MONITORING YEAR 1 ANNUAL REPORT

SHAKE RAG MITIGATION SITE

RE: Shake Rag Mitigation Site – Monitoring Year 1 Report Response to DMS Comments
French Broad River Basin – CU# 06010105 – Madison County
DMS Project ID No. 100018
Contract # 7190

Figure 3.0 Current Condition Plan View Map (Key)
 Shake Rag Mitigation Site
 DMS Project No. 100018
 Monitoring Year 1 - 2020
 Madison County, NC

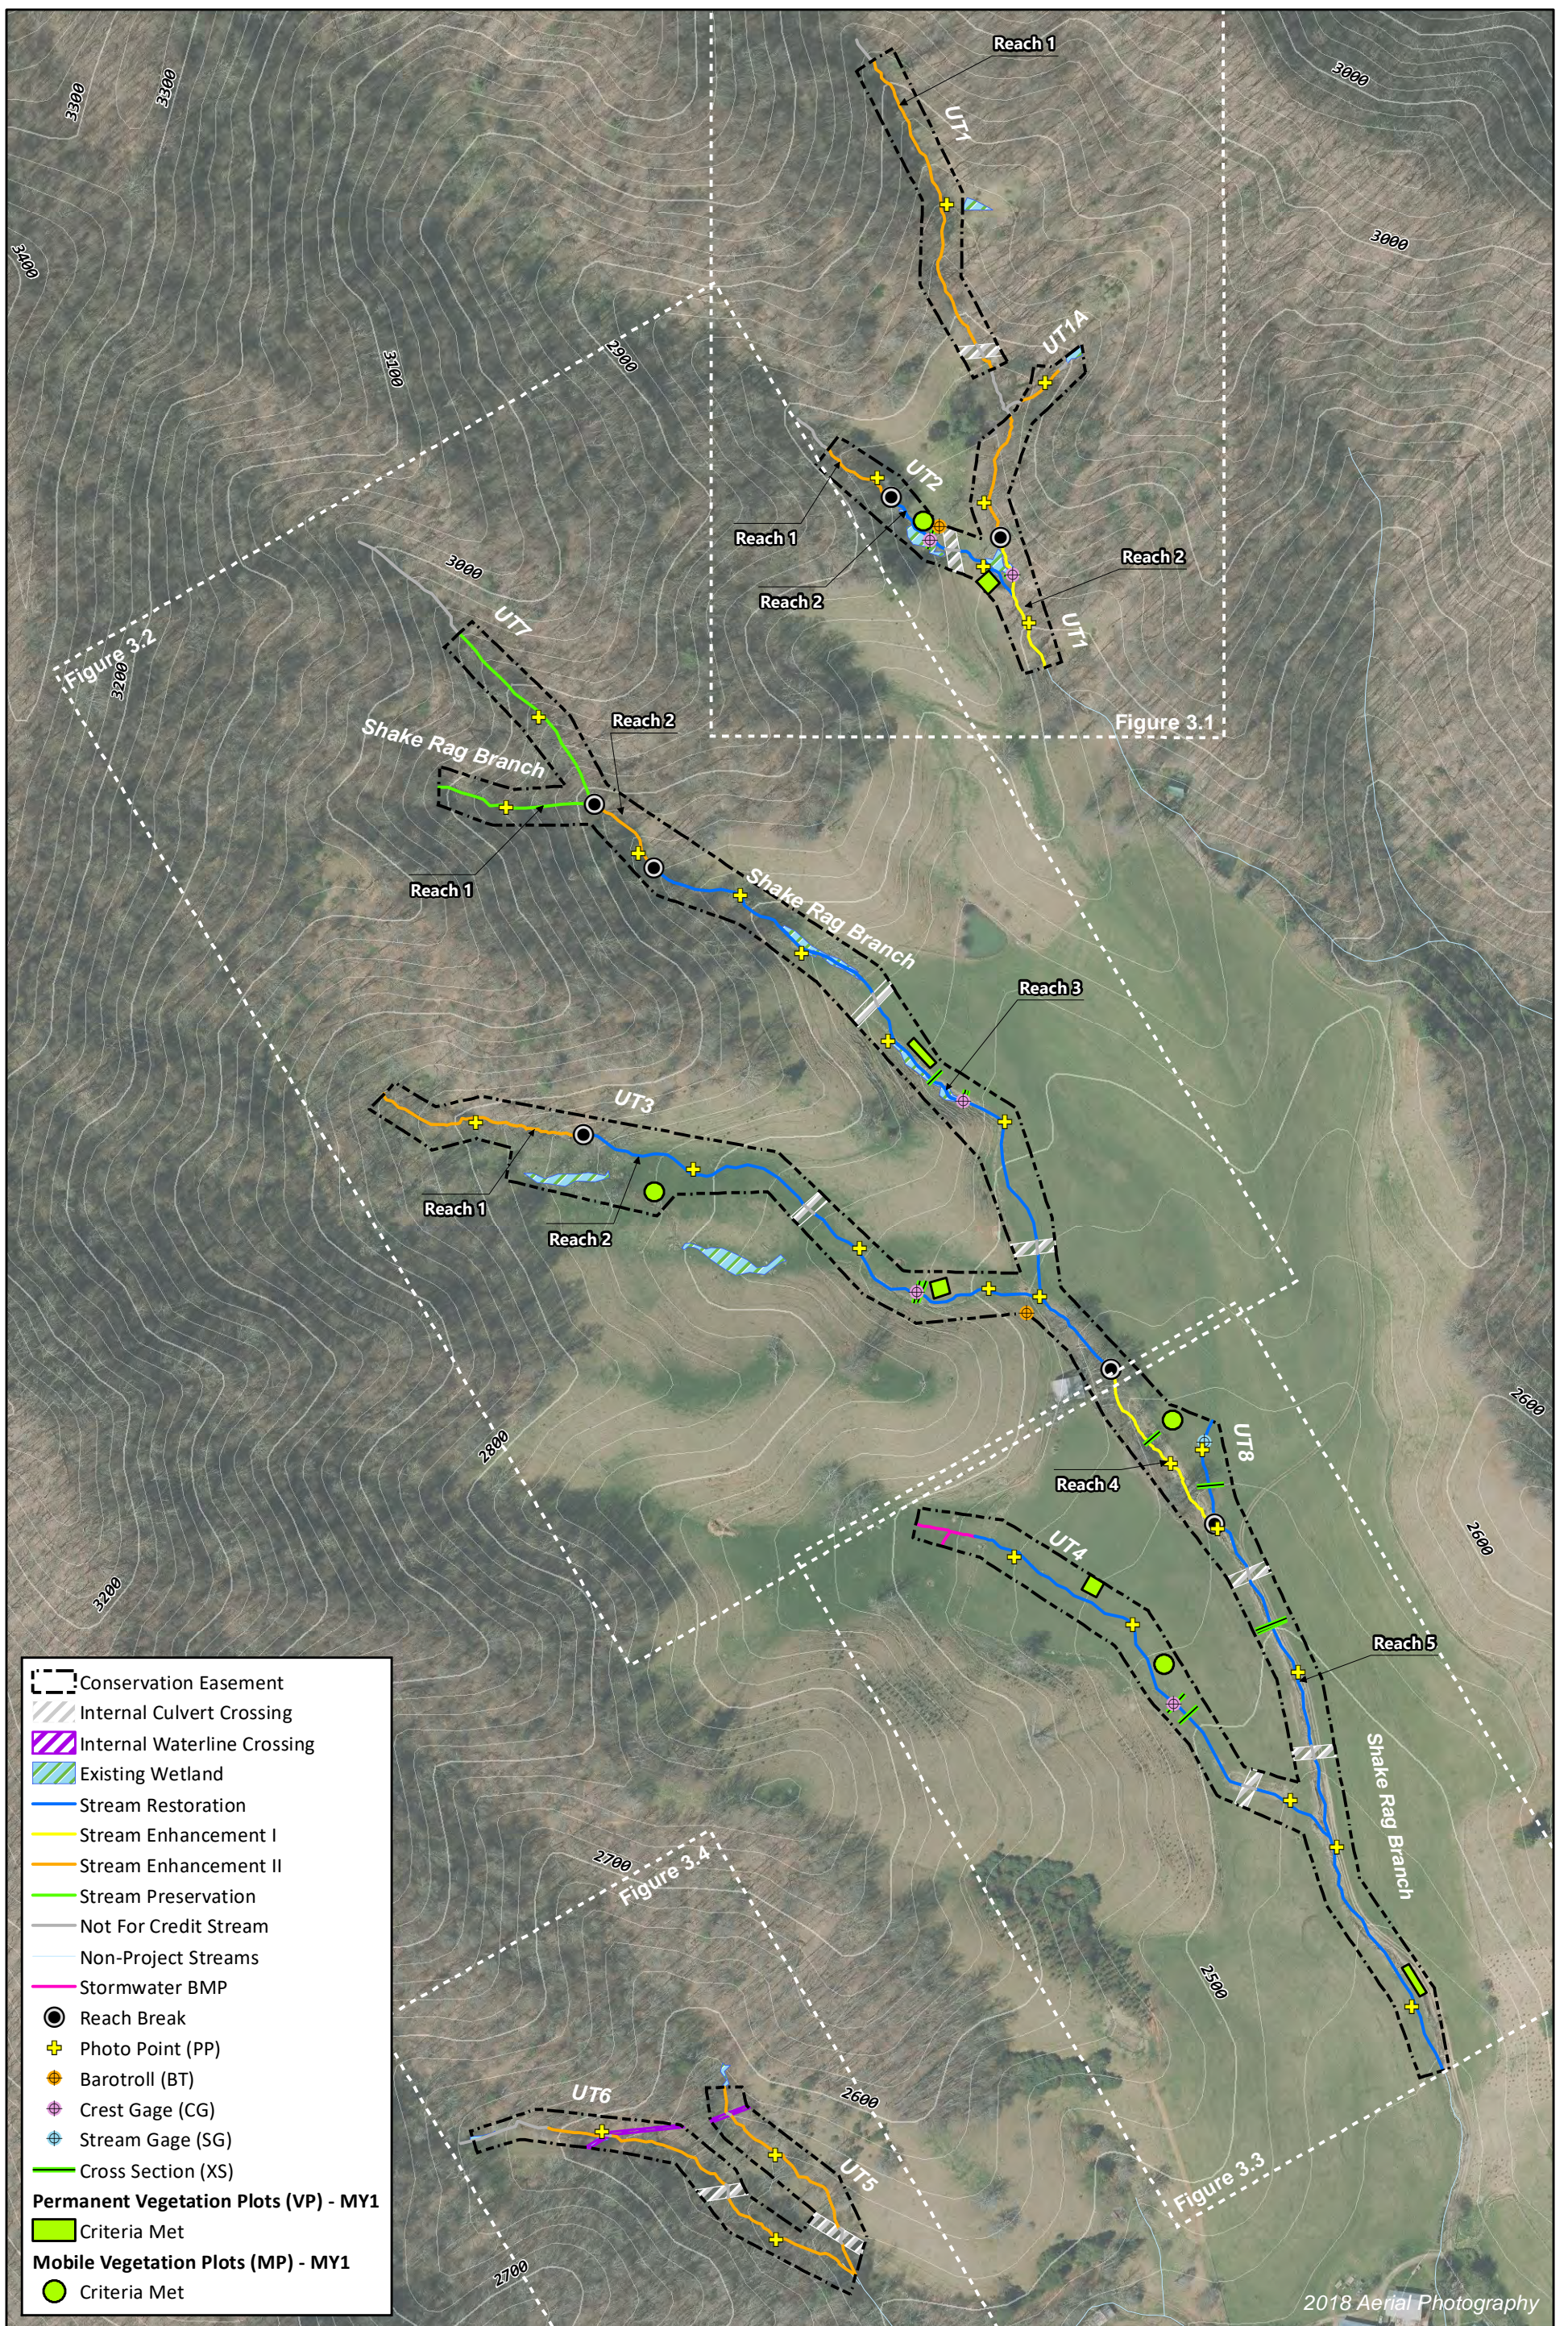
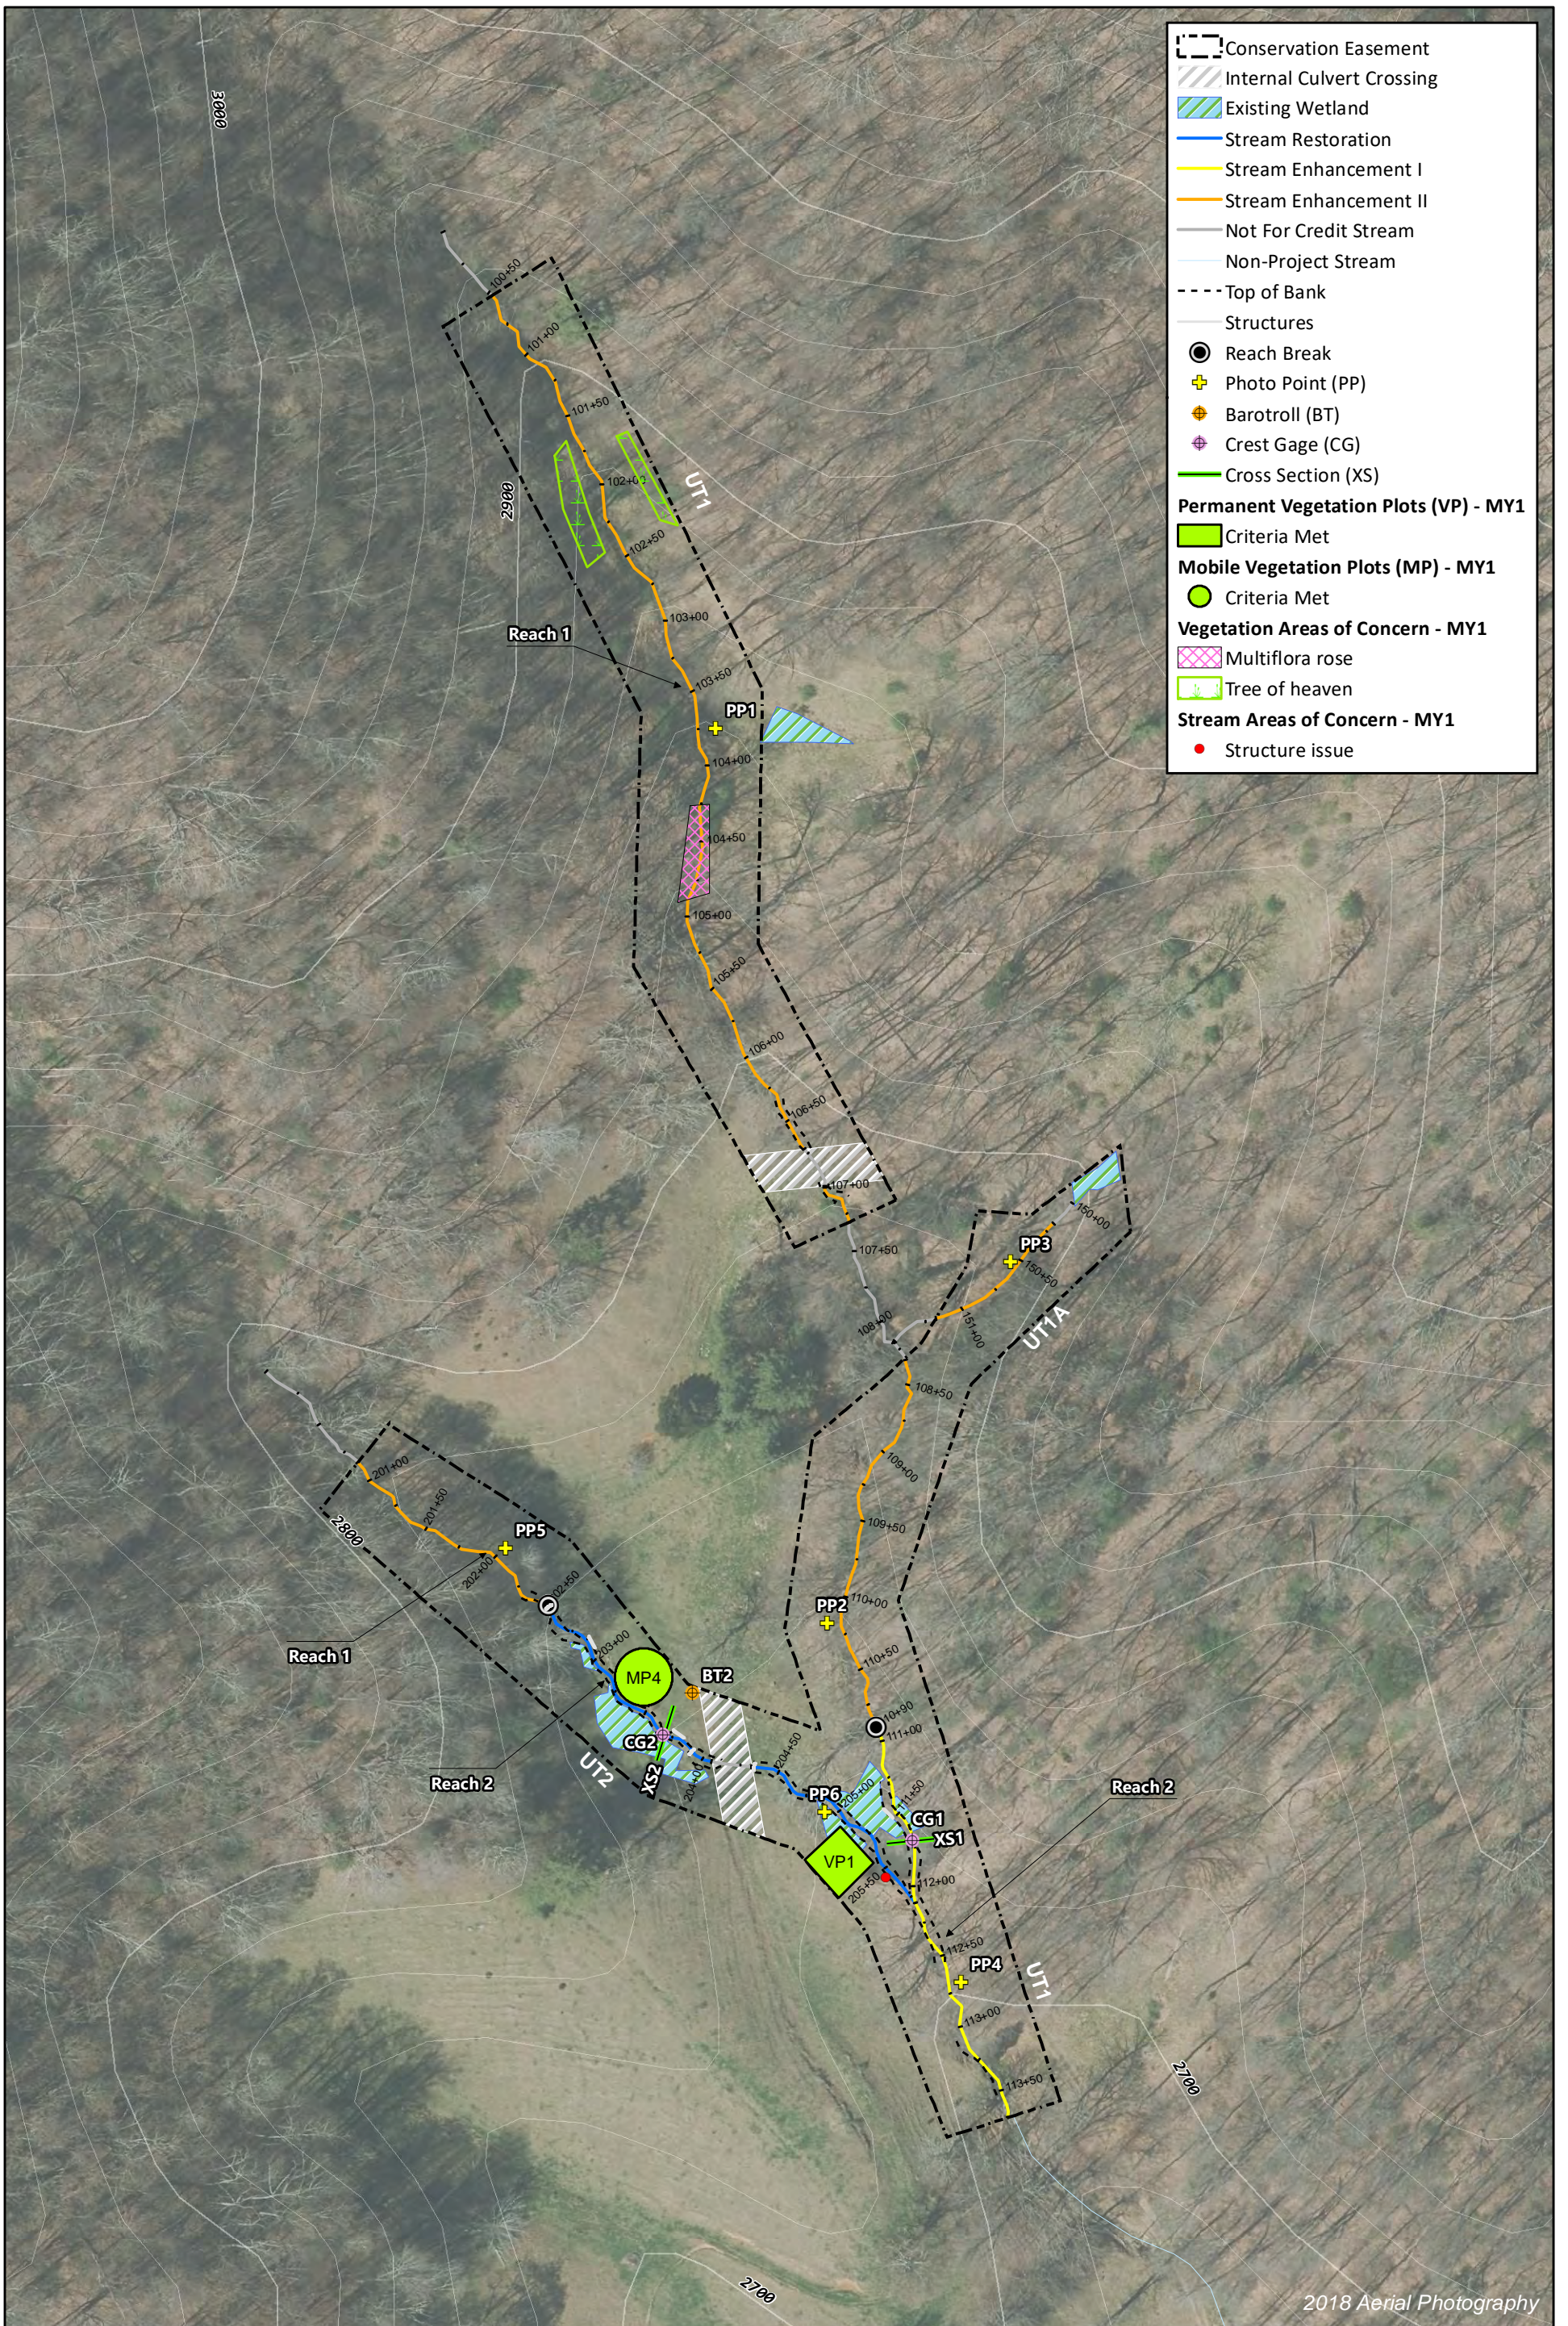
DMS comment: CCPV: The report (section 1.2.5) indicates that the areas of concern noted on the CCPV were repaired in November. If this is the case, please update the CCPV Legend to “Structure Issue – Repaired Nov. 2020” or something similar. It appears to the reviewer that these are current and ongoing problems. If there are known problem areas that developed after the repair or remain on-site, please mark those with a different symbol.

DMS comment: Tables 6b, 6c and 6d: These tables should represent what is currently on the ground and match what is shown on the CCPV. Are the numbers shown in the “Engineered Structures” category calculated using what was repaired or are these different problem areas? Please update as necessary along with CCPV.

Wildlands response: Since these areas of concern were repaired and no longer of issue, they were removed from the CCPV maps and associated stability tables.

Wildlands response: Tables 6b, 6c, and 6d have been updated to represent what is currently a known stream stability issue. As stated above, all repaired areas have been removed from the CCPV maps, and only current issues remain.
